ISO 14001 INSTALLATION SOIL CONDITIONS

Cambridge Field Works

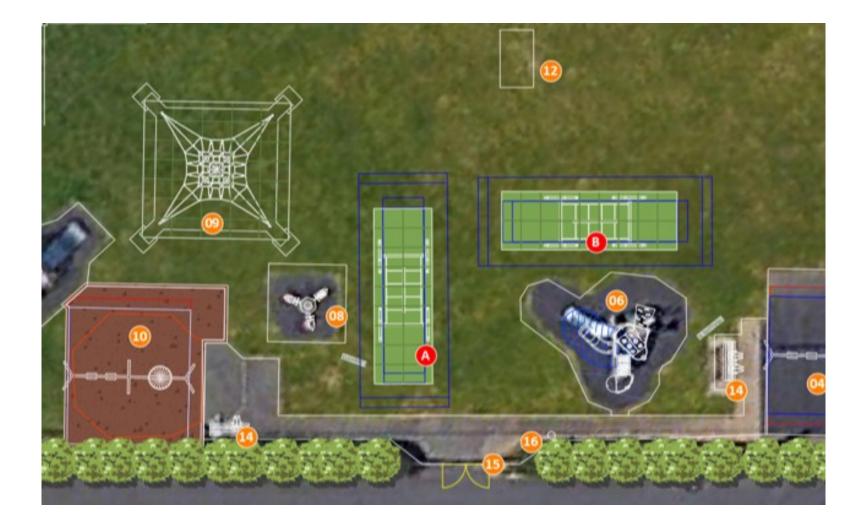
Location of the large rope swing needs to move as it is a bit close to the existing 3 way springer. Considering either location A or B or an alternative location within the park being considered by the consultant.

This is the agreed revision for the area to the right in terms of the surfacing from the site meeting (the 'infill with mulch' in blue writing is what is being offered at no extra cost).

The challenge all along were these small tarmac areas that are not perfect for a new playground, however there is a limited budget. Its only really aesthetics, and the main focus is the new equipment however perhaps something to think about.

I think there are two options: 1 is that we see if Sutcliffe can extend the surfacing to cover these two gaps shown which I cant see being a significant amount, or that it is part of Phase 2 to cover these up, or maybe even add in something small with surfacing in Phase 2.

• Sutcliffe have agreed to include some additional surfacing near the Supernova to effectively join the two areas over the existing tarmac which would not look great, so this will be a better finish at no extra cost.
